Highways Rebuttal to PoE

London Electricity Board Depot, Churchfields Road

CHURCHFIELDS ROAD DEPOT, CHURCHFIELDS ROAD, BECKENHAM

Rebuttal to Proof of Evidence by Nojan Rastani, London Borough of Bromley
Requested by SLR Consulting

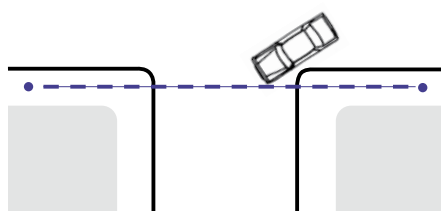
- 6.1 I have been asked by SLR Consulting to comment on a new drawing (ref. 237324/AT-D12), showing potential improvements to the site access road.
- 6.2 The key elements of this potential scheme include:
- i) replacement of the existing gates with a new set of gates set back 18 metres from Churchfields Road.
 - ii) A transition from the existing kerbed footway within the site access road, extending past the new gates and comprising a footway with 20mm bullnose kerb, leading to the existing marked virtual footway.

6.3 Whilst I do not consider these improvements essential to remedy an unsafe current situation, they undoubtedly provide some benefit. The gate set-back reduces the likelihood of arriving vehicles stopping on the carriageway and the extended footway provides added protection to the limited number pedestrians using the site access road. The give way markings provide extra clarity at the junction, benefitting all road users.
